RE: Ceja Vista Unit 1

Engineer's Certification Date: 03/18/21 Engineer's Stamp Date: 10/04/19 Hydrology File: P09D002F CPN # 614193 & 614195

Ceja Vista Offsites Unit 1

Request for ROFG/SIA

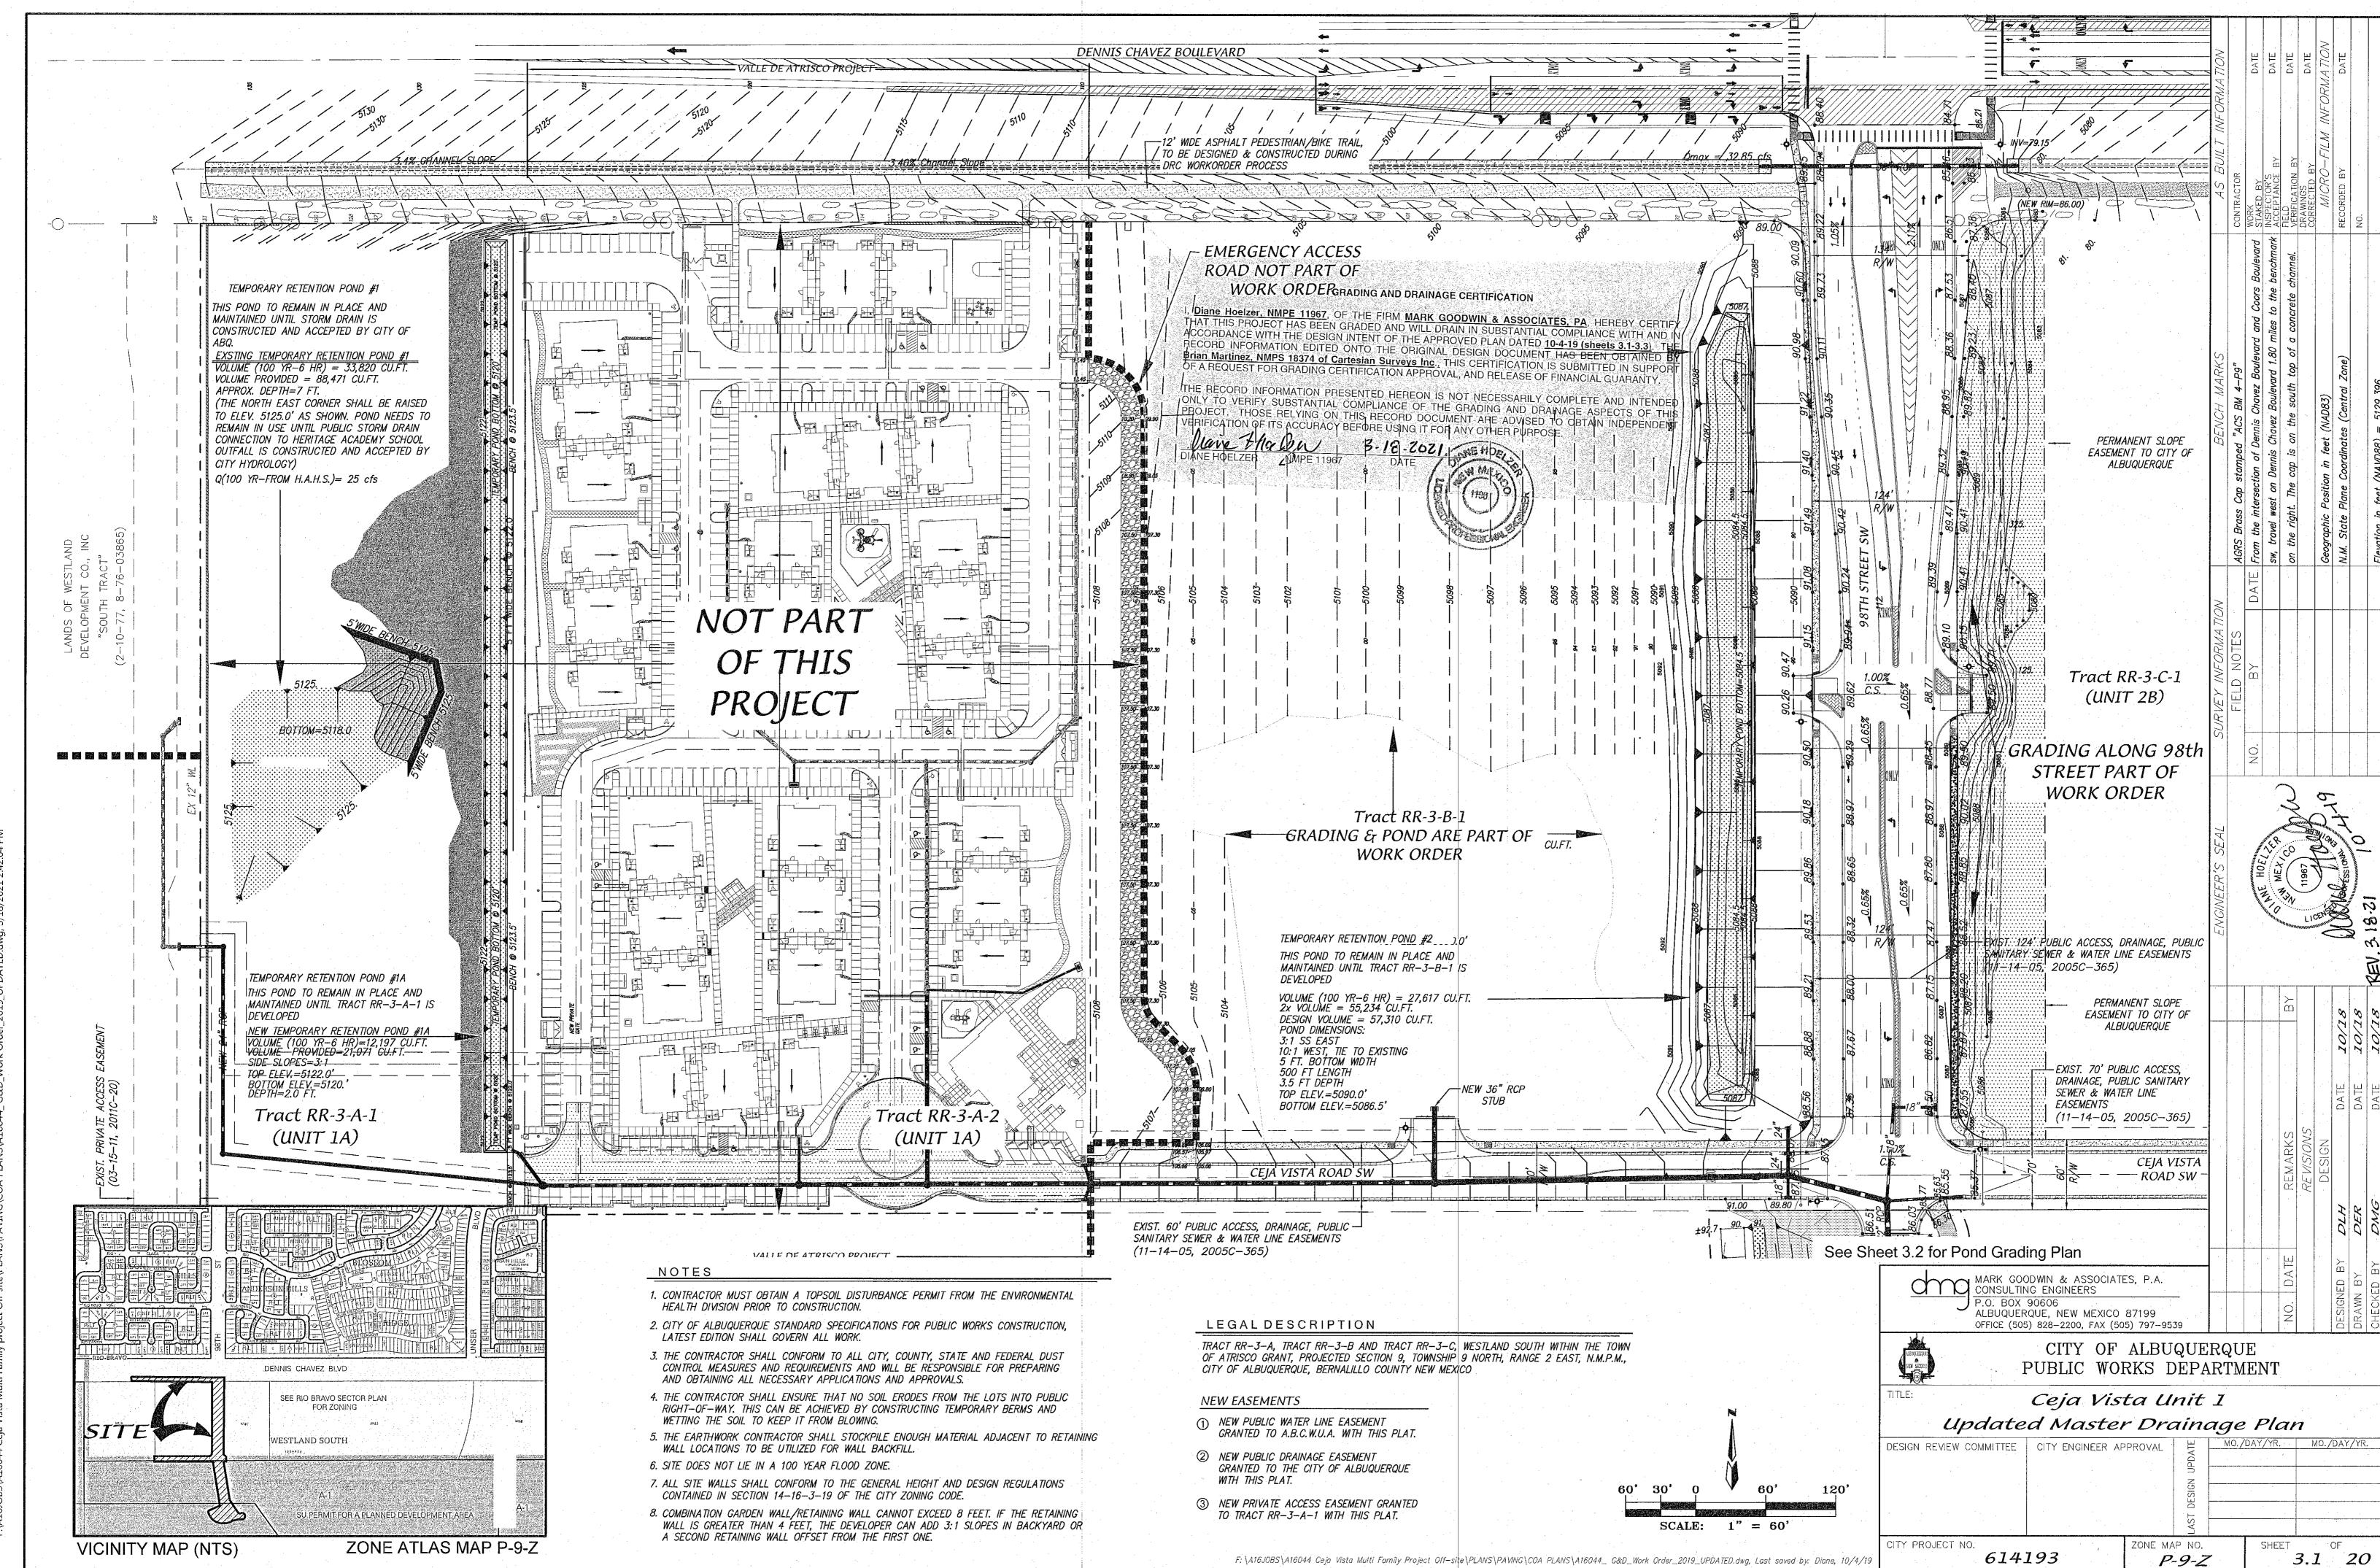
- 1. As built survey for the top and toe of the slope on the east side of 98th Street has been added to the grading plan. The as built contours have been added into the plan and replotted.

- 2. Tumble weeds have been removed from the channel. I didn't see any silt fence in the channel.
- Side slopes adjacent to the channel have been reduced to 10:1 maximum. Survey along the top and bottom of slope are shown on the plan. As built survey contours along the maintenance road have been added.

- 4. The pond volume has been verified as shown on the plan. There is an existing berm around the pond. Silt fencing has been added along the crest of the berm. There was a spillway constructed but blowing sand has diminished it. A copy of the raw as built contour survey is included with this resubmittal.

- 5. The contractor is going to reconstruct the grades around the curb return within the Valle de Atrisco Apts. There should have been a crown section in this area but it was not constructed that way. The drainage from this site will be intercepted by one of the two inlets. The as built for this section is not part of this submittal. It is part of the Valle De Atrisco Apt. grading and drainage plan and will be addressed and re-submitted on that plan.

- 6. The riprap at the end of the outfall pipe is part of the Ceja Vista Unit 1 Phase II construction plans. The design was modified during DRC and will be shown on the DRC as builts.

With this re-submittal is a copy of the raw as built survey and a copy of the survey with contour line elevations show which are included as an attachment to the original 10-4-19 approved plans. The pond volumes were recalculated and are shown on this resubmittal. The spillway into the pond was replaced with wire enclosed rip rap over filter material as called out on sheet 3.3.
